From: Planning@horsham.gov.uk
Sent: 24 July 2026 11:34
To: Planning
Subject: Comments for Planning Application DC/26/0946

Address:	Steyning Cricket Club Charlton Street Steyning West Sussex BN44 3LE
Proposal:	Demolition of the existing club house and changing building and the construction of a new single storey pavilion and part 1.5 storey changing facility with associated landscaping and storage areas
Case Officer:	Shazia Penne

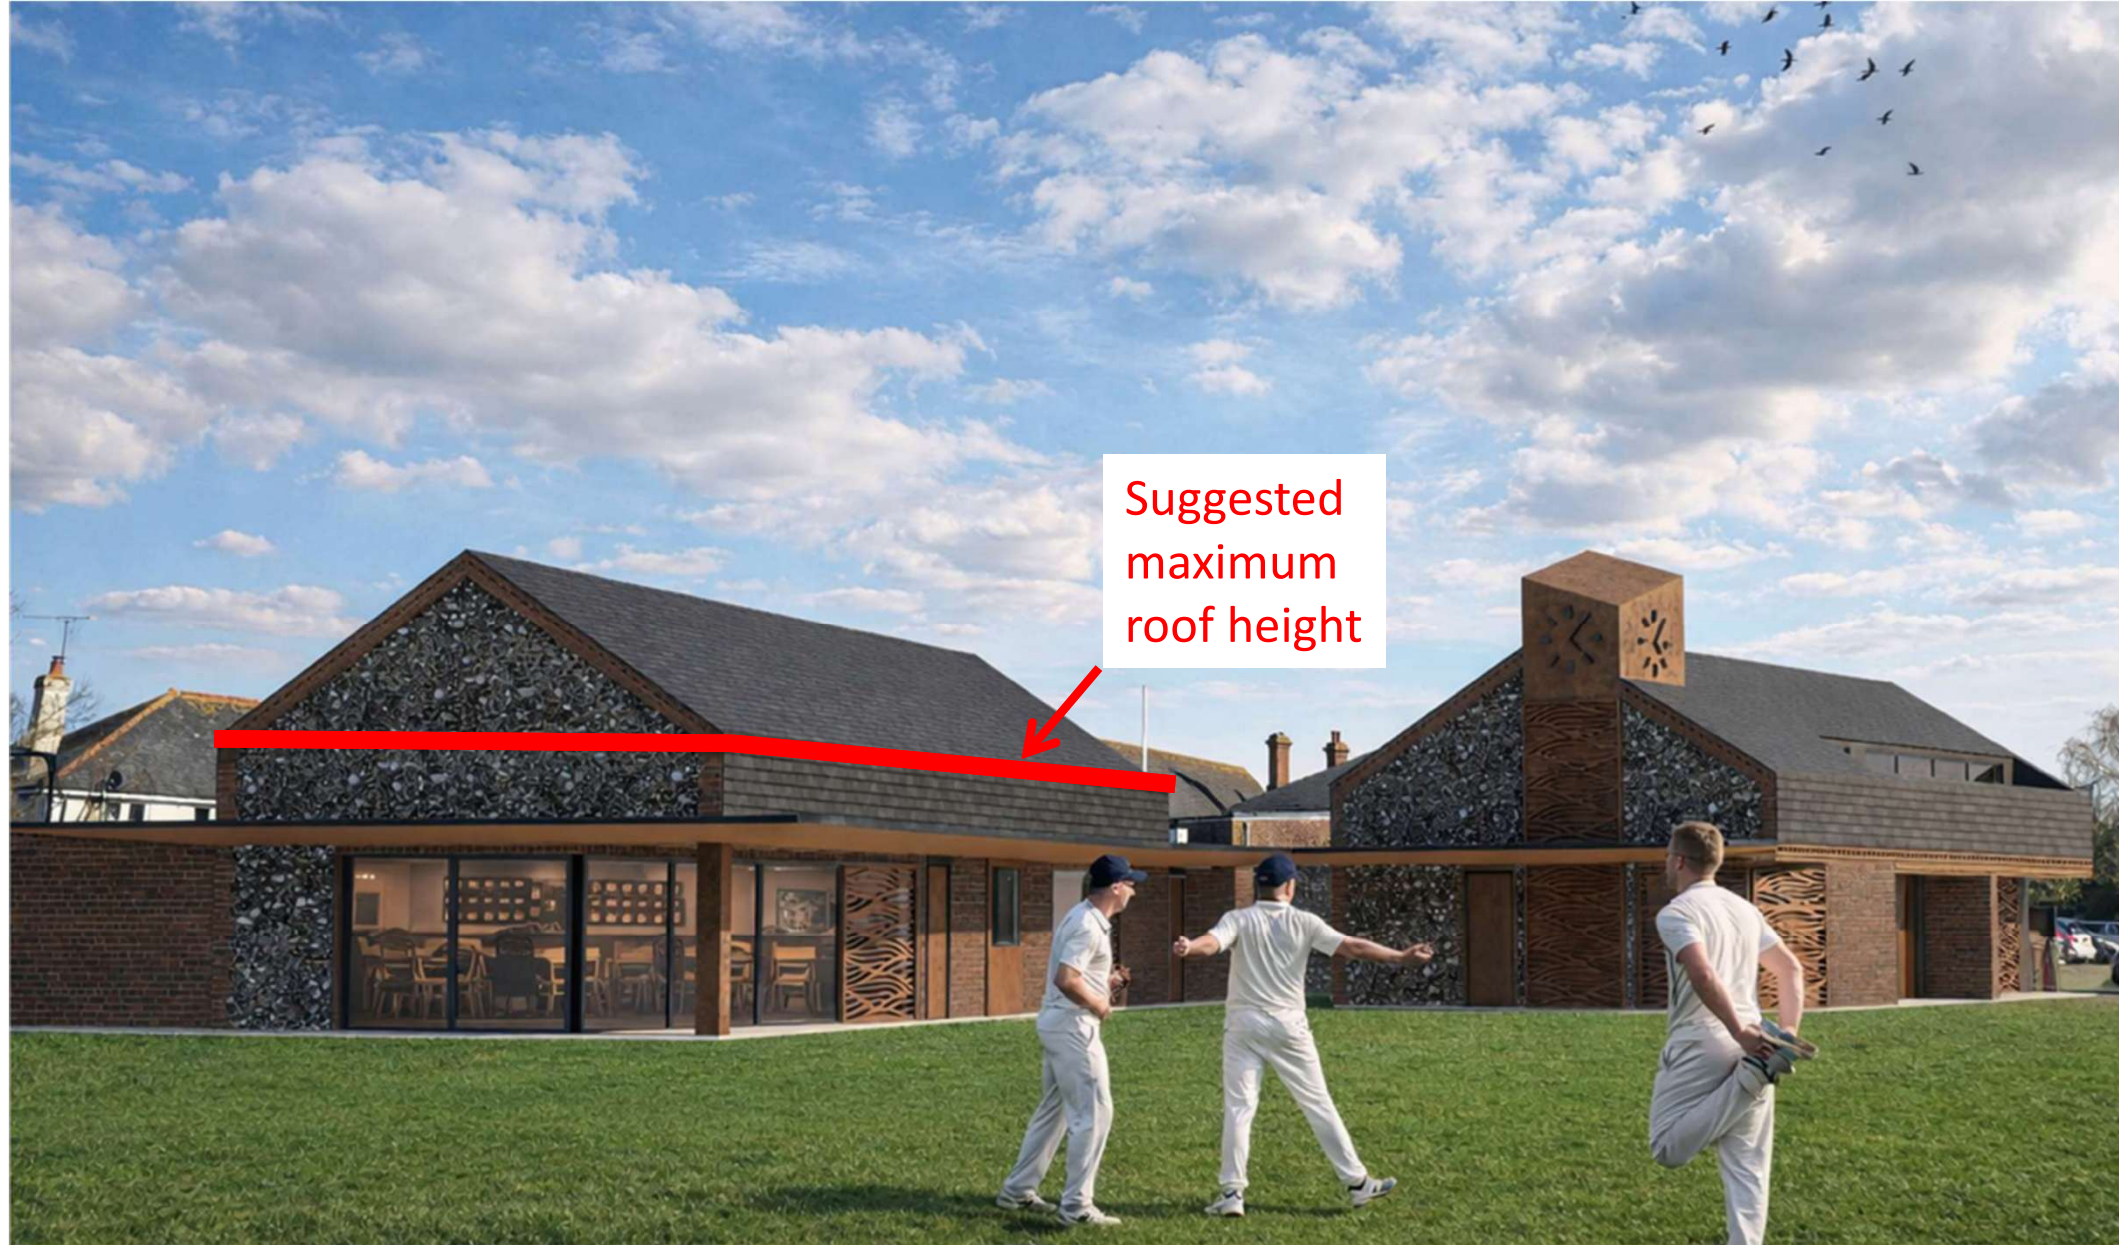
1. The proposed gable roof over the bar area (see Supporting Design Document 12.03) is nearly twice the height of the current pavilion and produces a dark and unsympathetic visual barrier between the playing field and the interesting townscape / roof scape of Charlton Street behind. It also blocks glimpses of the Downs for pedestrians in Charlton Street (eg between 1 the Plough and 3 The Gardens). For the neighbours living behind, it creates a dark barrier between them and the Downs.

Suggestion: We suggest the gable roof is removed and replaced by a flat roof, which could be slightly higher than the remainder of the flat roof to create architectural interest and some increase in internal height over the bar area. This would result in a less imposing, less dark and more friendly building with much less of a barrier between the town and the Downs. See the attached visual showing suggested line of the amended roof. (Sent by separate email)

I think my wording was a bit unclear in the final paragraph of my comments.

I said ' The adverse visual impact would be much reduced, and the forbidding character of the building would be lessened if the gable was removed from the pavilion building and replaced with another, slightly higher, flat roof.'

I should have said 'replaced with another flat roof, slightly higher than the surrounding one' . I didn't mean slightly higher than the gable!

I hope it's clear what from the attachment.

Reducing the roof height of the Pavilion as suggested would:

- Greatly reduce the visual impact and loss of light for neighbouring properties
- Make the building less imposing and out of place when viewed from the playing field
- Be more in keeping with the function of the building as a sports pavilion
- Still provide architectural interest
